BAUGHMAN COMPANY
 APARTMENTS
LINE 1
Sta. 0+00 to Sta. 8+27.2
 SANITARY SEWER
 PROJECT NUMBER: 21-08-15049
 DATE: 12/28/2022
 SHEET: 2 OF 19

BAUGHMAN COMPANY
 APARTMENTS
LINE 2
Sta. 0+00 to Sta. 4+74.1
 SANITARY SEWER
 PROJECT NUMBER: 21-08-E800
 DESIGN TEAM: JAW, JAW, JAW
 DATE: March 28, 2022
 SHEET: **3** OF **19**

APARTMENTS
EROSION CONTROL PLAN
 SANITARY SEWER
 PROJECT NUMBER: 21-08-E600
 RESIDENT TOWN: AVANTE TOWN
 DATE: FEBRUARY 16, 2022

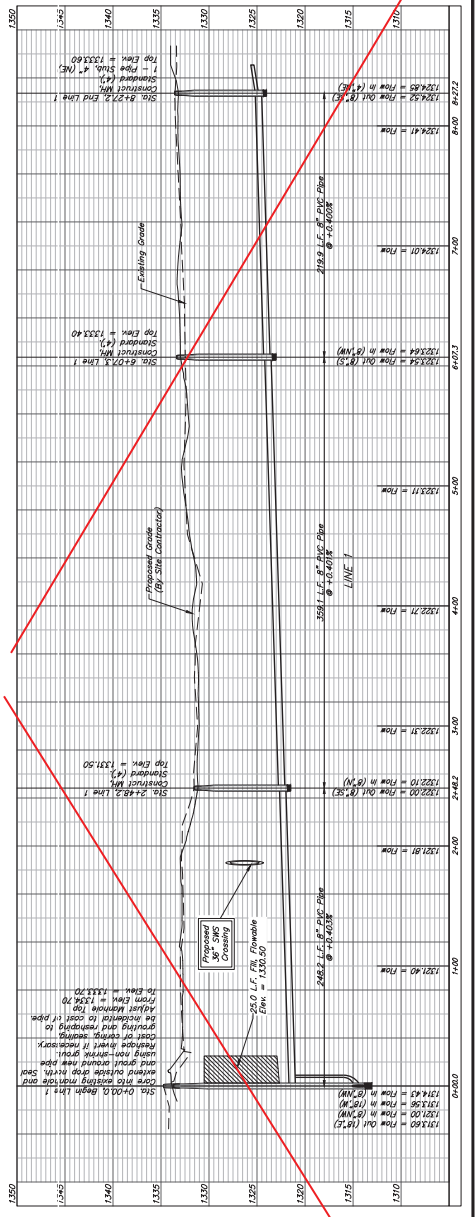
SS LINE 1: ALIGNMENT REVISED. SEE PREVIOUS SHEET.

BAUGHMAN COMPANY
 APARTMENTS
 LINE 4
 Sta. 0+00 to Sta. 3+54.2
 SANITARY SEWER
 PROJECT NUMBER: 21-08-E800
 DESIGN: T.O.W. DRAWN: T.W.S.
 DATE: March 28, 2022
 SHEET 5 OF 19

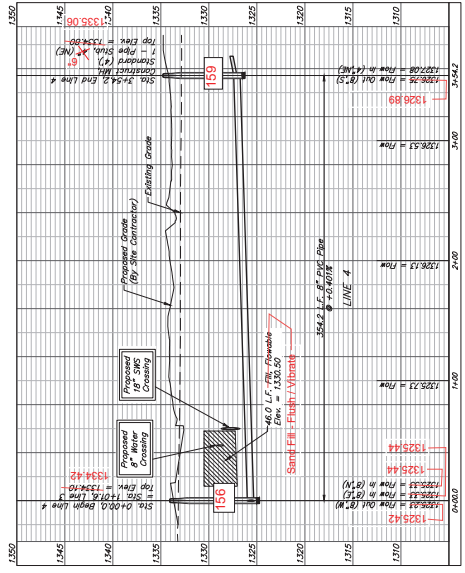
4-4-2022:
 All Sanitary Sewer locations specifying Flowable Fill was switched to "Sand Fill - Flush / Vibrate", with Baughman's approval. LDP

Sand Fill - Flush / Vibrato
